DATE:	May 7, 2021	CO #:	Five (5)
TO:	Standafer Builders 1178 West Main Street P.O. Box 247 West Liberty, Kentucky 41472	PROJECT:	Estill County Bus Garage Irvine, Kentucky BG# 19-340 RTA 1837
CONTRACT DATE:	November 18, 2019	CONTRACT FOR:	General Construction

**PROPOSED  
CHANGE ORDER****No. 15****TITLE:** PR09-R1: canopy lights**DATE:** 04/29/2021**PROJECT:** Estill Co. Bus Garage

**TITLE:** PR10: re-circuiting for bus power pedestals

**TITLE:** PR 11 Infrared heater relocation

FIRST FLOOR POWER/SYSTEMS PLAN  
1/8" = 1'-0"

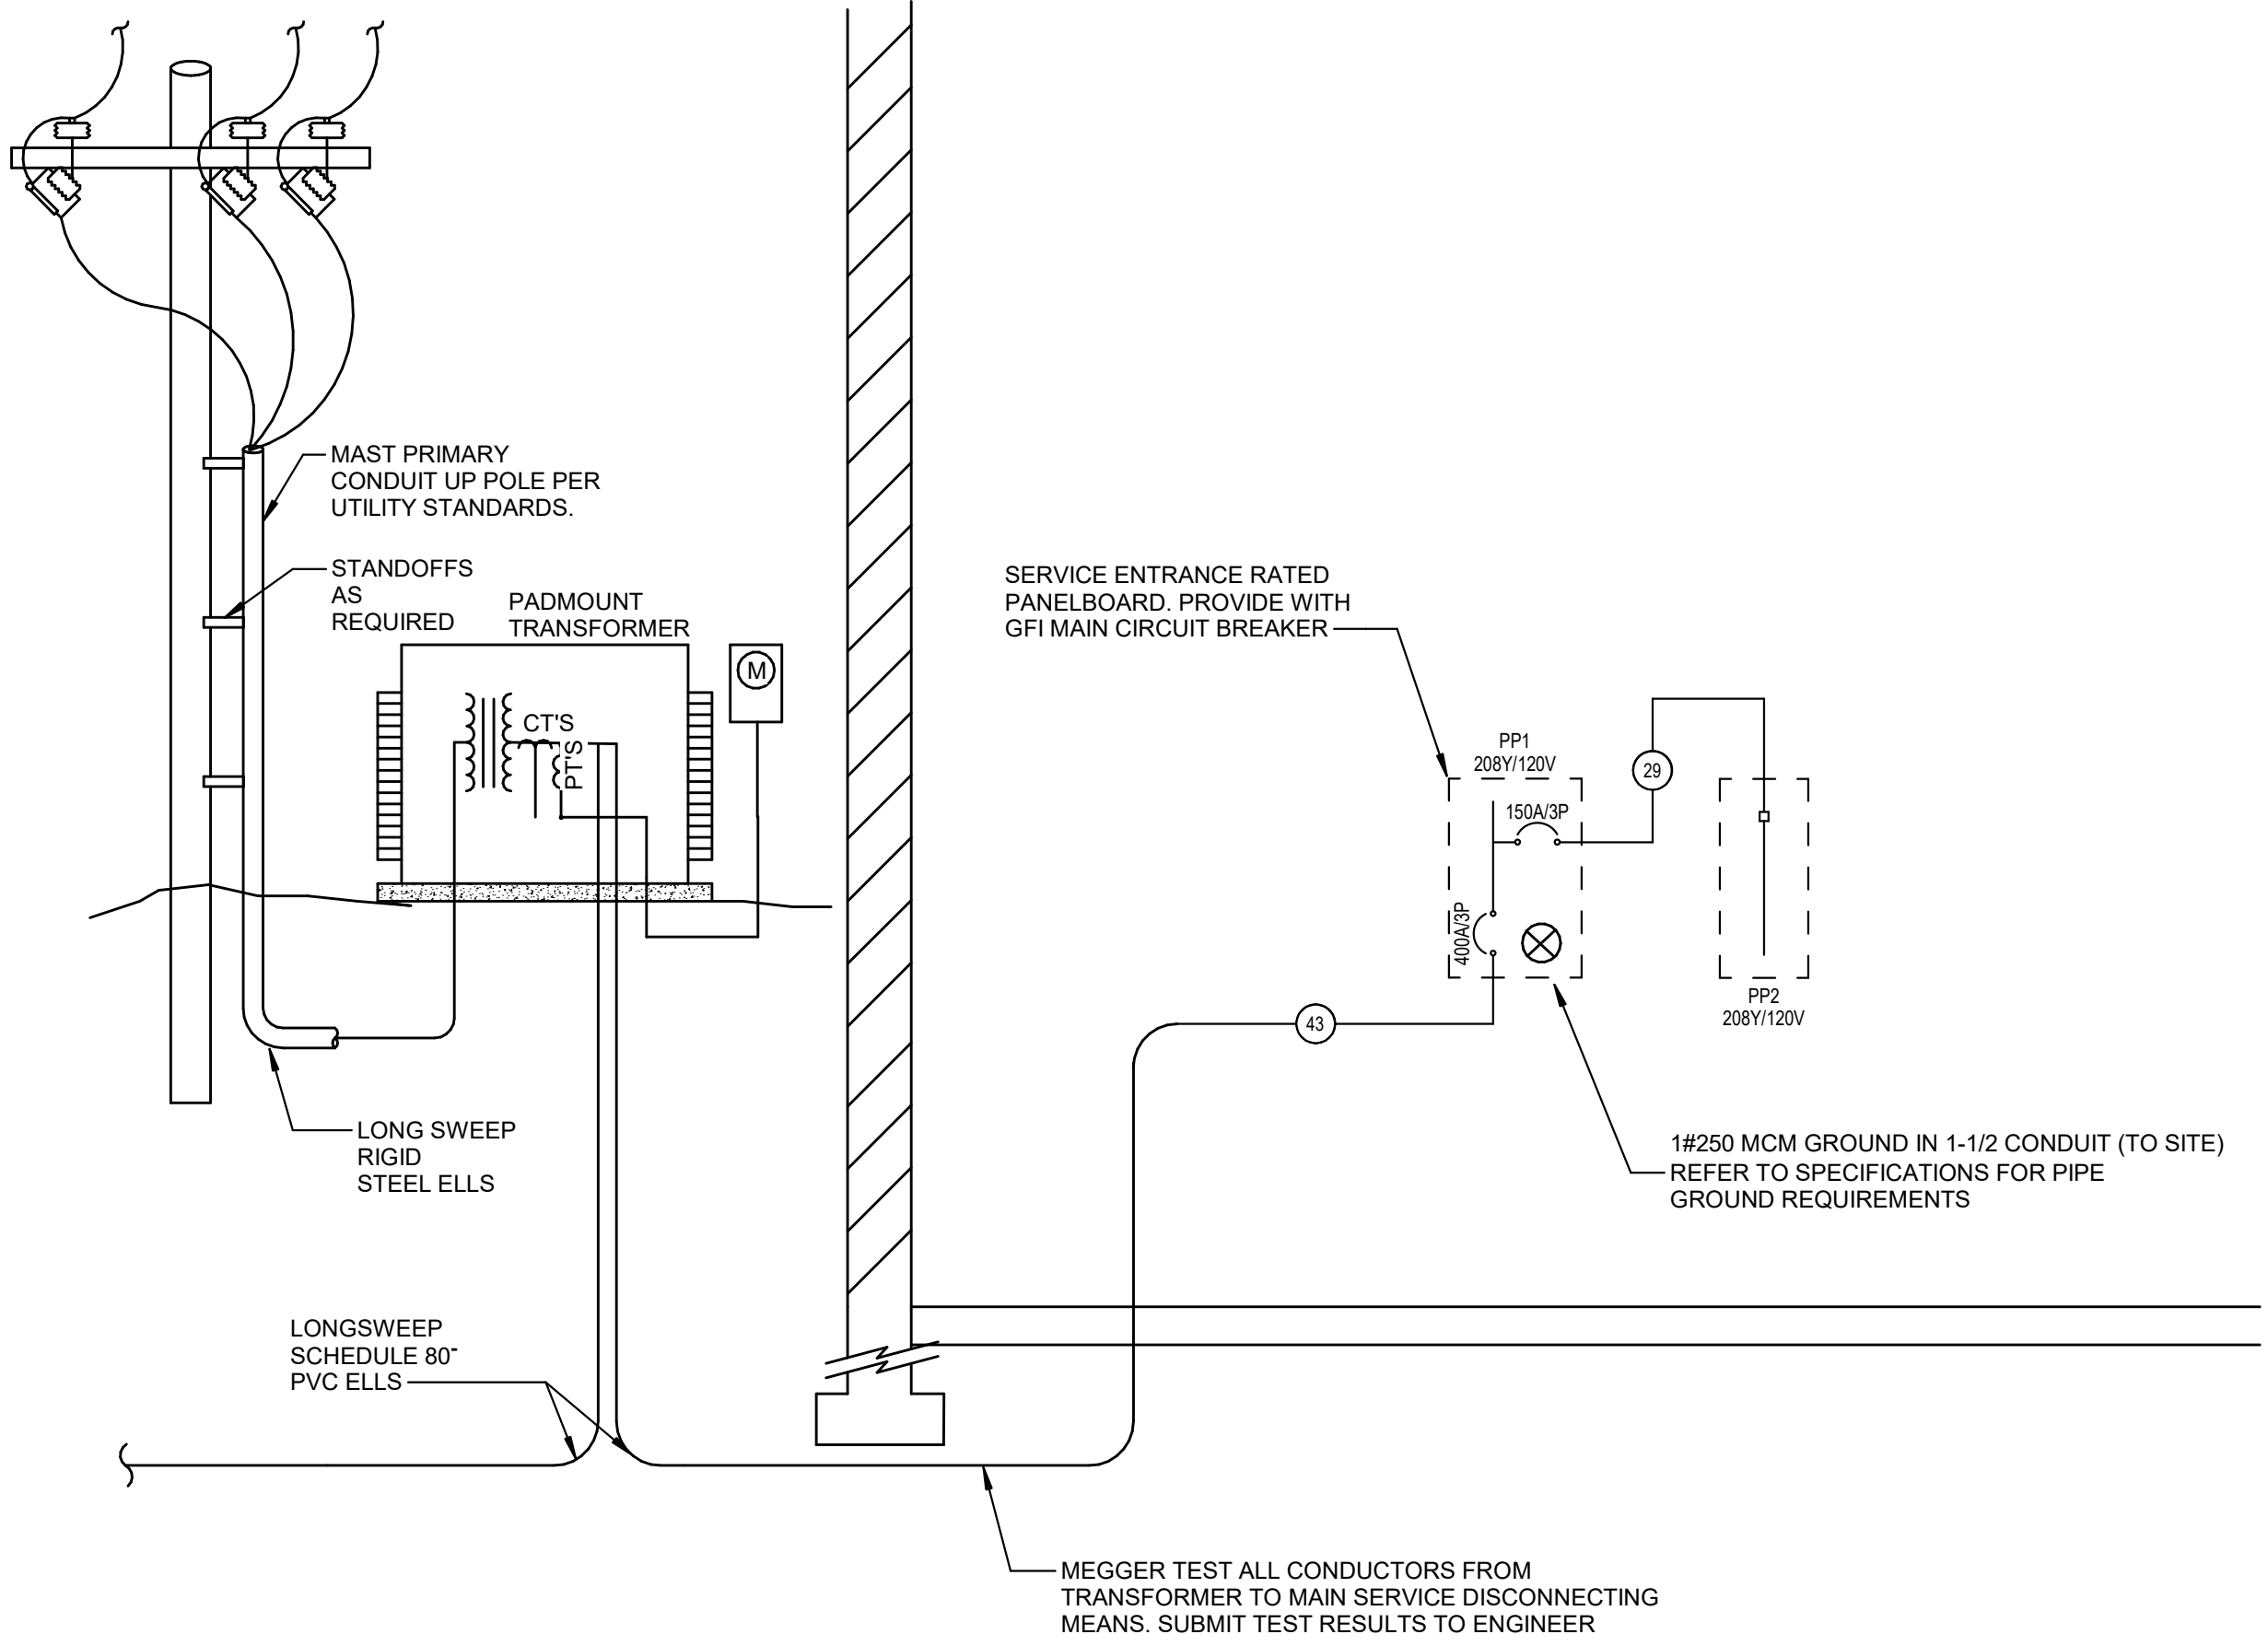
- In accordance with PR 09 and Contractor provided proposed pricing with COP 08, Contractor is to revise the canopy lighting electrical work as indicated within revision cloud on attached drawing E2.0.  
\$5,086.45
- In accordance with PR 10 and Contractor provided proposed pricing with COP 09, Contractor is to provide re-circuiting for bus power pedestals as indicated within revision cloud on attached drawing UE1.0  
\$4,945.00
- In accordance with PR 11 and Contractor provided proposed pricing with COP 10, Contractor is to relocate the bus bay infrared heater.  
\$2,455.66

- We propose labor & materials to install (4) Type OA Fixtures as specified under the fuel canopy as requested
- We will install conduit to bottom of the canopy structure and tie into existing circuit as indicated on PR-09
- We will pull new circuit thru existing conduit as indicated on revised PR-09
- All work will meet NEC 2017

See attached revised PR drawings for the Fuel Canopy Lighting. CMTA has provided this revised drawing which calls out using the spare conductors the owner located in the canopy wire way.

- E63 MOUNT FIXTURE ON SIDE OF CANOPY STRUCTURAL MEMBER.
- E64 ROUTE CONDUITS ALONG CANOPY STRUCTURAL MEMBER, ROUTE INTO FIXTURE JUNCTION BOX. PAINT CONDUITS TO MATCH CANOPY. ALL EXPOSED CONDUITS SHALL BE RIGID STEEL.

- E65 ROUTE CONDUIT OUT BOTTOM OF INSIDE FIXTURE, UNDER STRUCTURE CANOPY, INTO BOTTOM OF OUTSIDE FIXTURE. UTILIZE PULLING ELBOWS.
- E66 ROUTE CONDUIT DOWN COLUMN TO WIREWAY. ENTER BACK OF WIREWAY. INTERCEPT EXISTING SPARE CONDUCTORS FROM PANEL AND EXTEND #12, #12 GROUND TO LIGHT FIXTURES.

- E67 INTERCEPT EXISTING CONDUCTORS TO EXTERIOR WIREWAY. ROUTE CONDUCTOR THROUGH NEW LIGHTING RELAY TO PROVIDE CONTROL OF CANOPY FIXTURES VIA PHOTOCELL ON LIGHTING CONTROLS NETWORK. CONNECT CIRCUIT TO NEAREST UNSWITCHED LIGHTING CIRCUIT.

ELECTRICAL SITE UTILITIES PLAN  
1" = 30'-0"

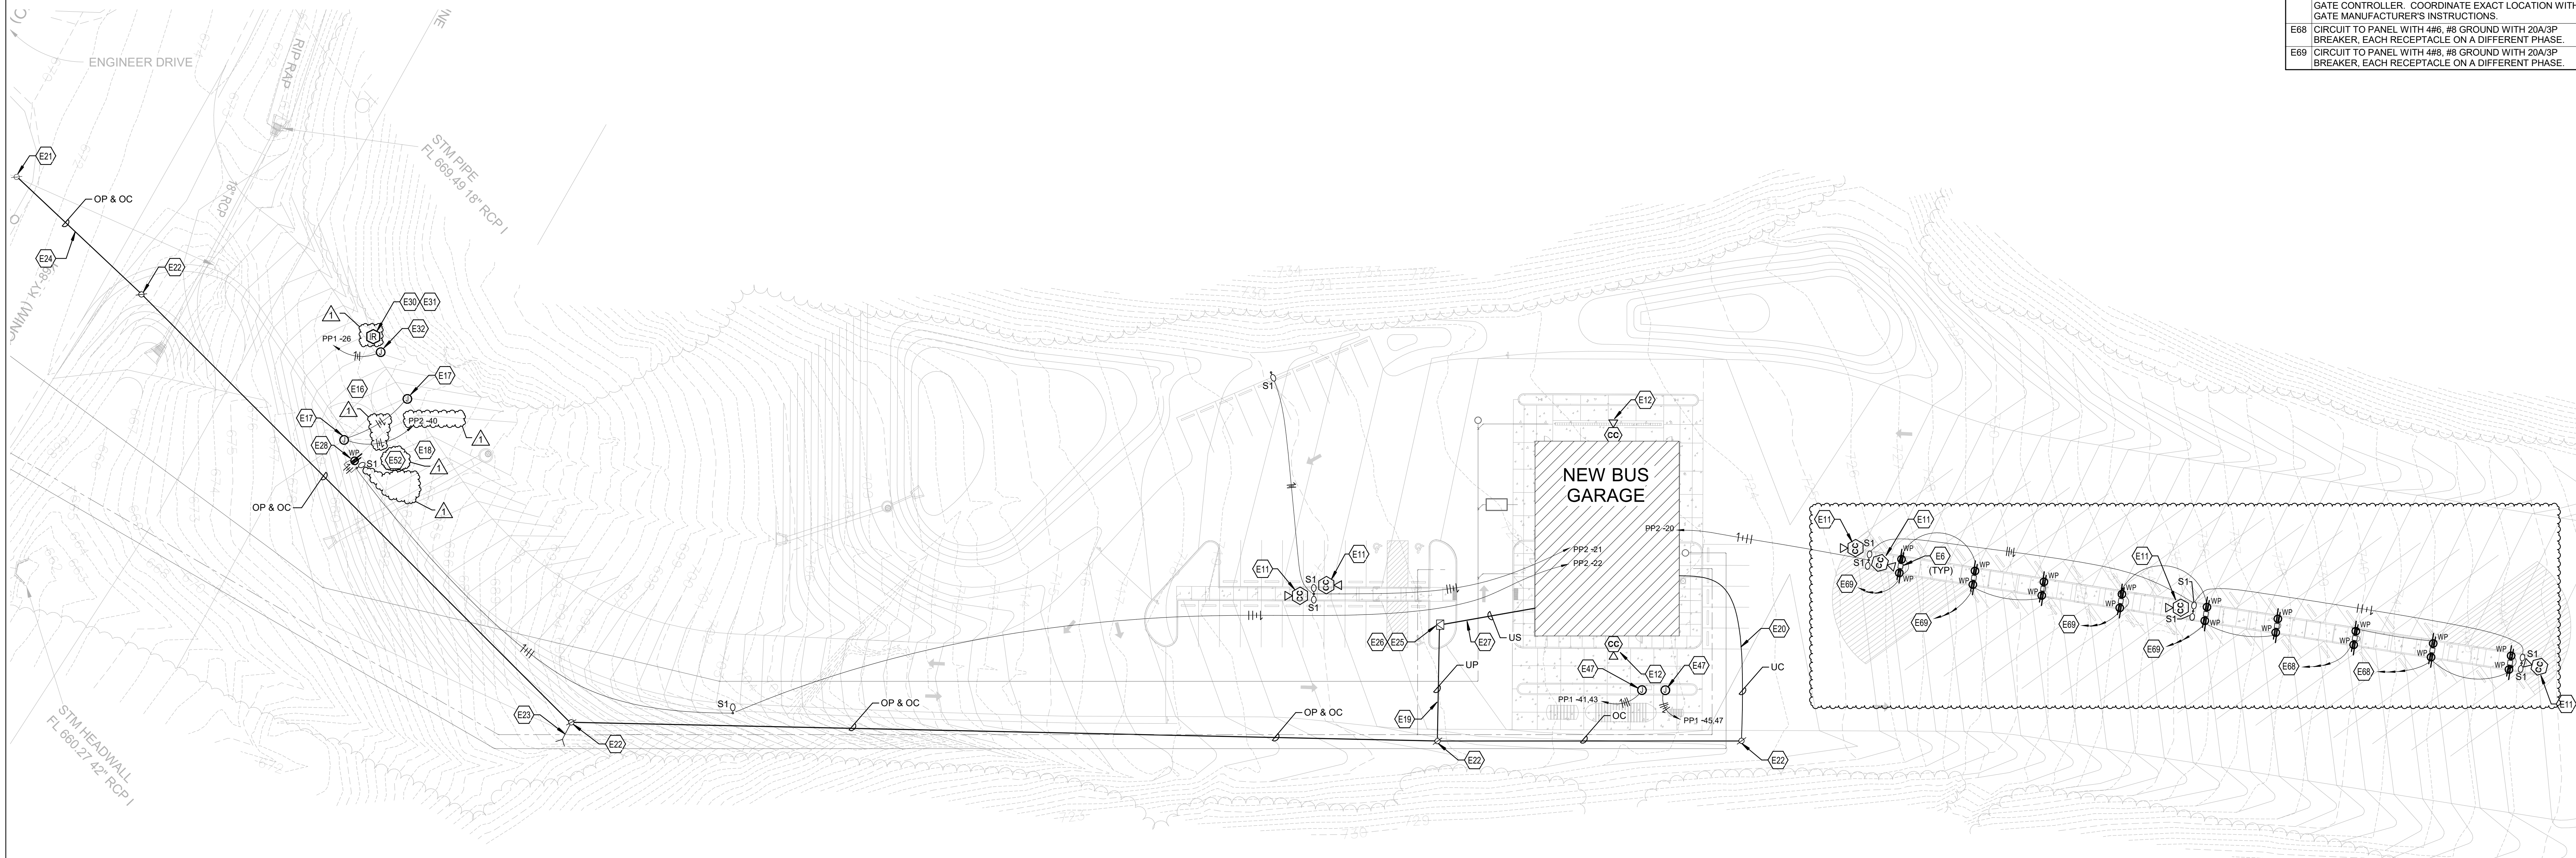
Per PR 10 to provide re-circuiting for bus power pedestals as indicated within revision cloud on attached drawing UE1.0.

*We will remove existing single pole breakers & replace with (6) 3Pole 20Amp Using shared Neutrals to allow for the addition of 24 new dedicated circuits as requested.*

Provide re-circuiting for bus power pedestals as indicated within revision cloud on attached drawing UE1.0. See attached PR drawing.

- E68 CIRCUIT TO PANEL WITH #46, #6 GROUND WITH 20A/3P BREAKER, EACH RECEPTACLE ON A DIFFERENT PHASE.
- E69 CIRCUIT TO PANEL WITH #46, #6 GROUND WITH 20A/3P BREAKER, EACH RECEPTACLE ON A DIFFERENT PHASE.

Re: **Estill County Bus Garage**  
RTA Project: 1837  
CMTA Project: XEBG18  
General Contractor: Standafer Builders  
**Infrared Heater Proposal: 2021-01-04**

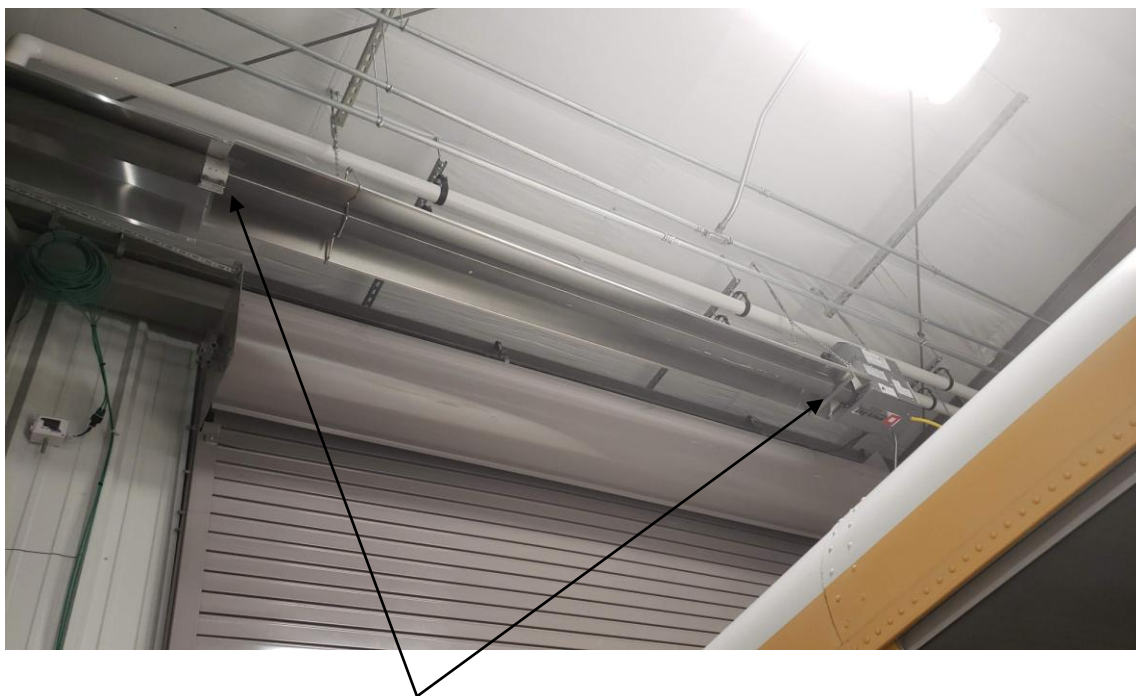
Please provide pricing to rework and shorten the Infrared heater steel emitter tubes.

Remove a ten foot section of the steel radiant emitter tube and reflector.

Rework and extend the gas controller box, gas pipe supply and the power receptacle serving the controller to the revised control box location. Complete the final terminations of electrical power, thermostat and gas to the relocated gas control box.
